# 1988 - 1990 Corvette: Service Bulletin: Power Steering Shudder / Groan

**Subject:** POWER STEERING SHUDDER/GROAN INSTALL P/S COOLER & HOSE

**Model and Year:** 1988-90 CORVETTE WITH 5.7L ENGINE

**Bulletin Number:** 90-376-3B - (10/25/1990)

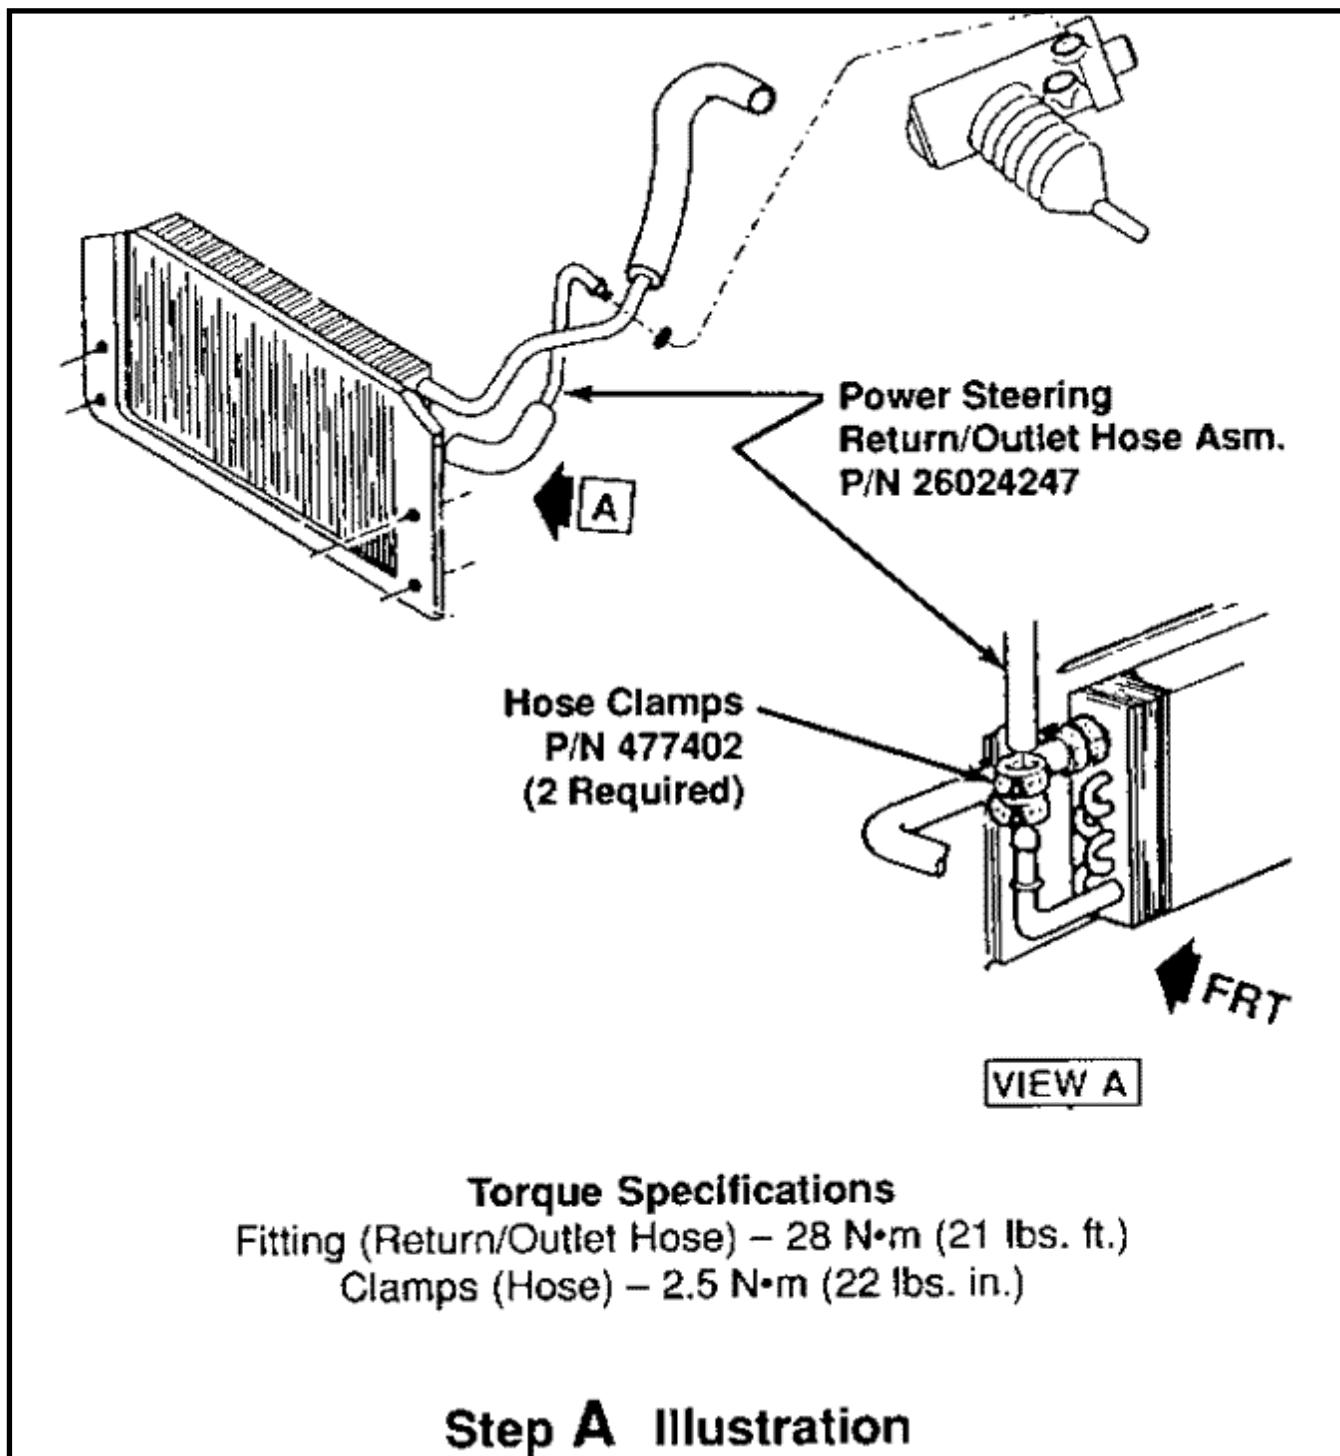
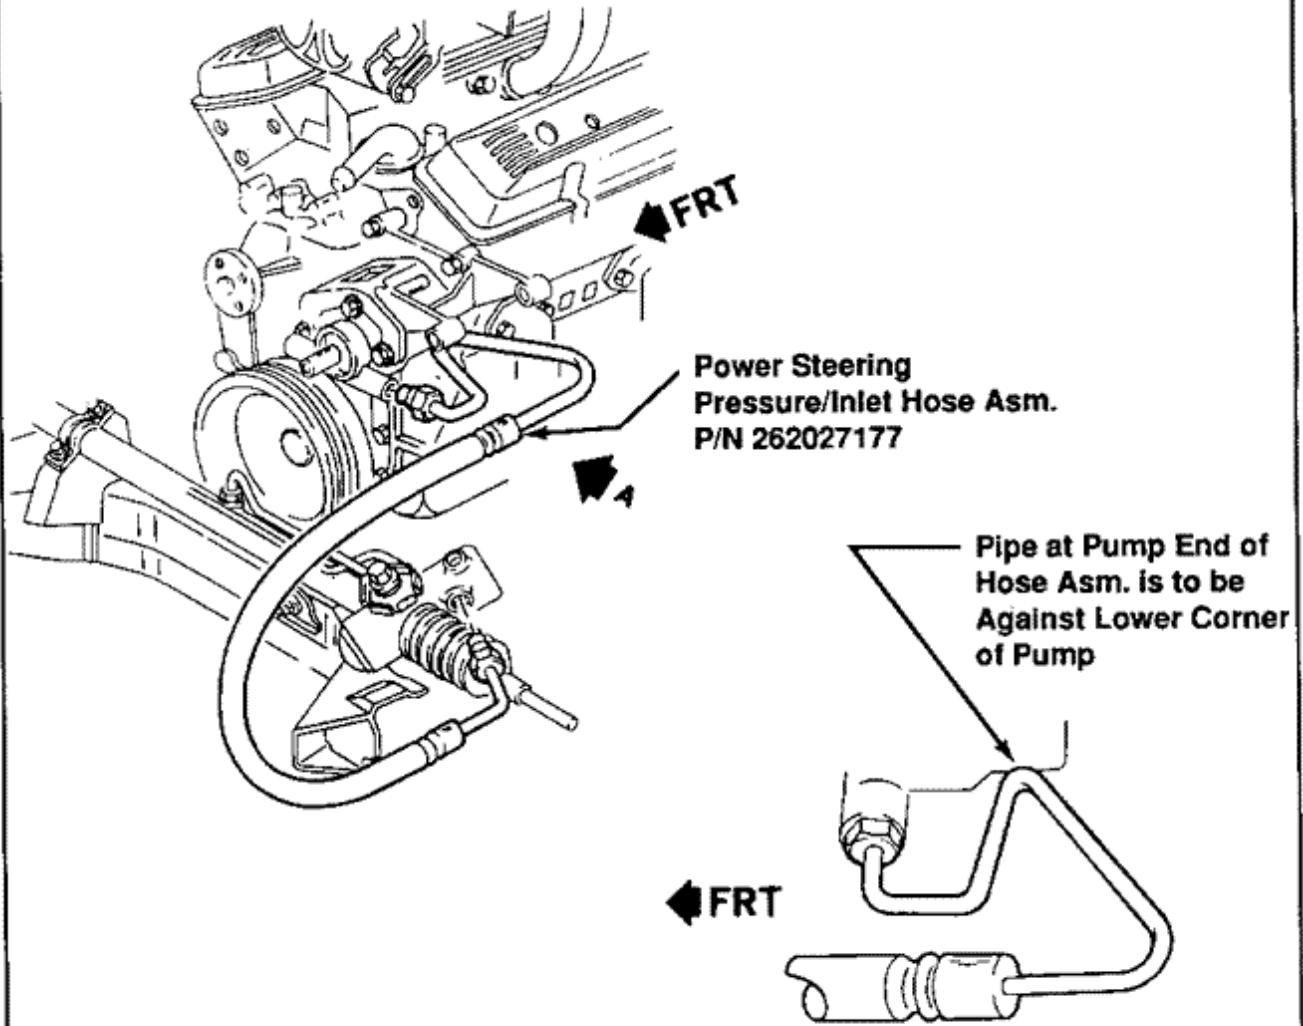
Replace existing return hose (steering gear to cooler) with new assembly with internal tuner cable.

On applicable 1990 vehicles as designated by VIN breakpoints indicated in step matrix, replace existing power steering gear.

**Step B Illustration**

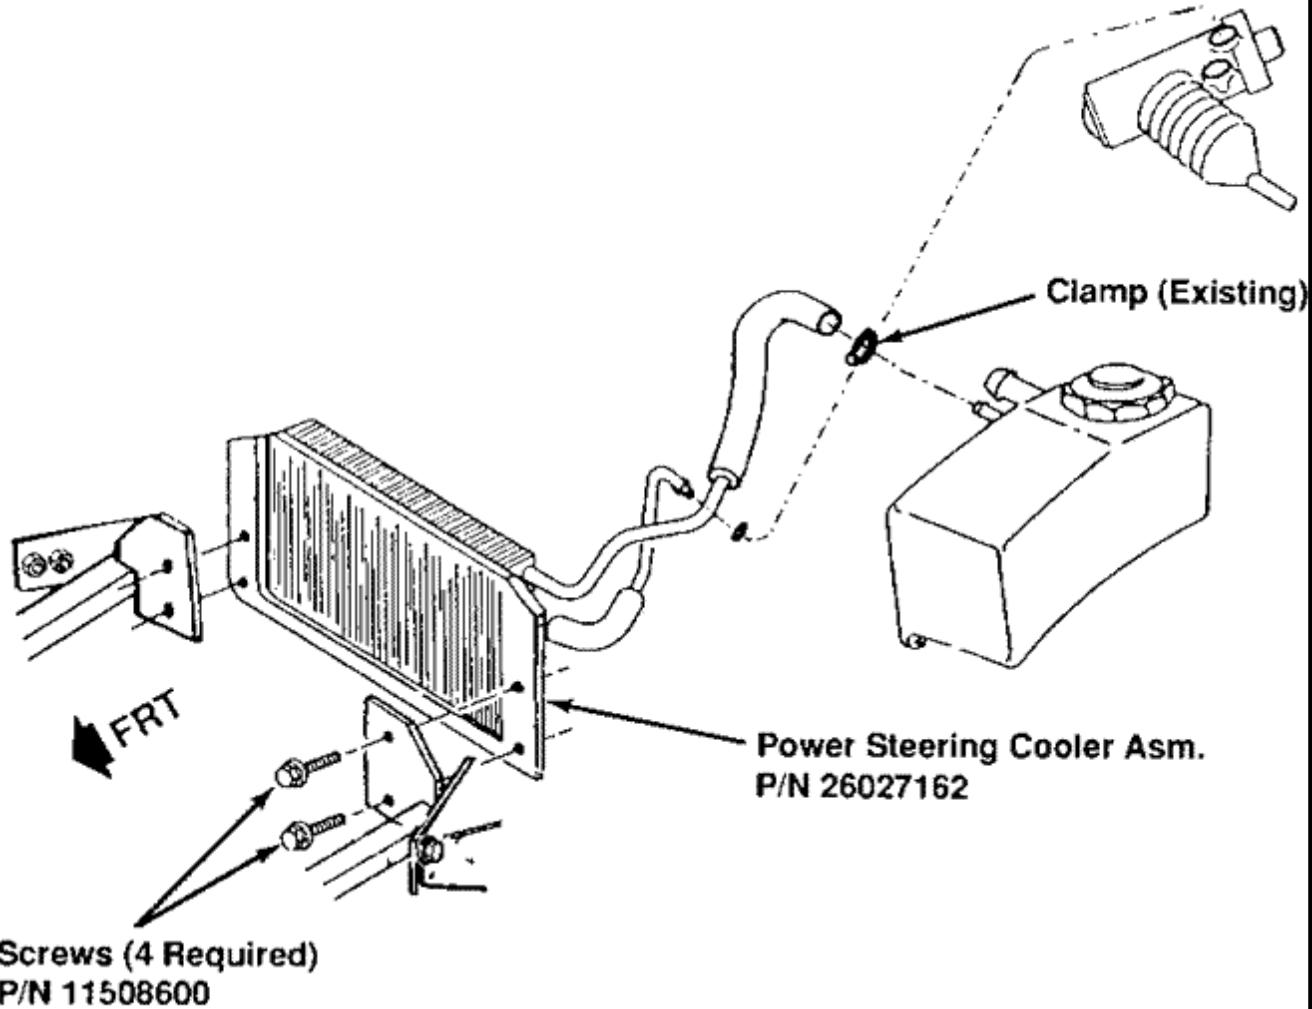
Replace existing pressure/inlet hose (pump to steering gear) with new assembly with internal tuner cable.

**Torque Specifications**  
Fittings (Pressure/Inlet Hose) – 28 N·m (21 lbs. ft.)

**Step C Illustration (1990 Vehicles)**

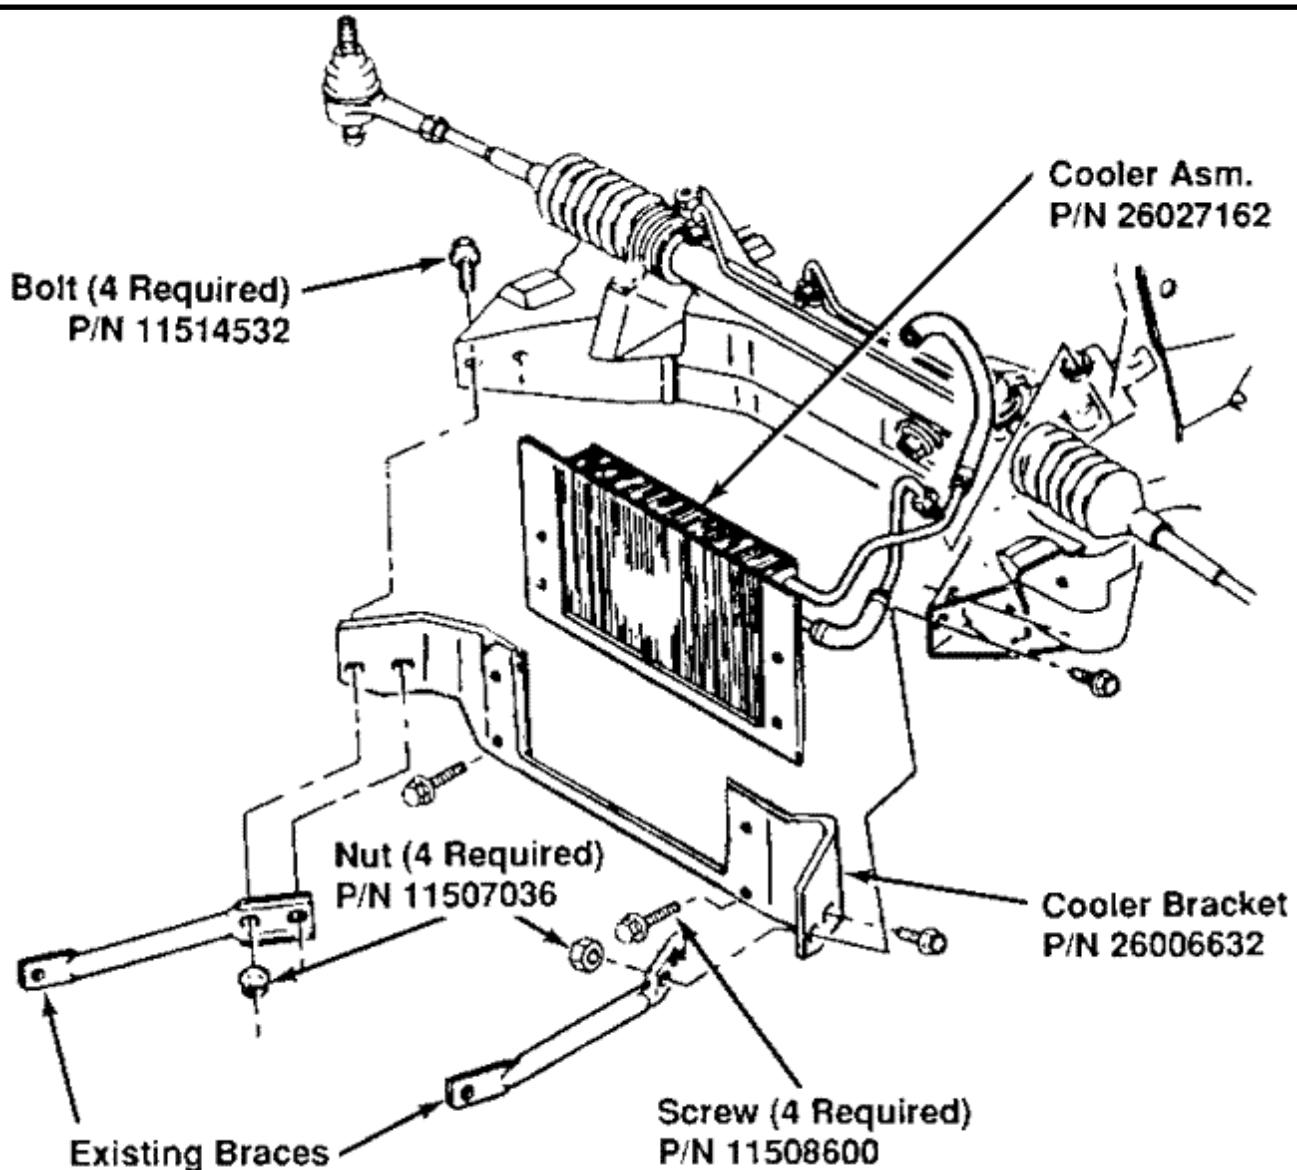
Replace existing power steering loop/pipe cooler with finned cooler that includes return hose with tuner cable.

#### Torque Specifications

Fitting (Return/Outlet Hose) – 28 N·m (21 lbs. ft.)

Clamp (Reservoir Hose) – 2.5 N·m (22 lbs. in.)

Screws (Cooler/Bracket) – 10 N·m (89 lbs. in.)

### **Step D Illustration**

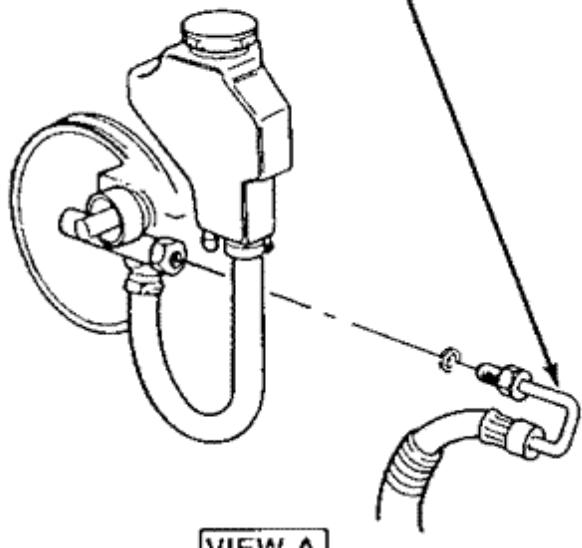
Replace existing pressure inlet hose (pump to steering gear) with new assembly with internal tuner cable.

**Torque Specifications**  
Fittings (Pressure/Inlet Hose) – 28 N·m (21 lbs ft.)
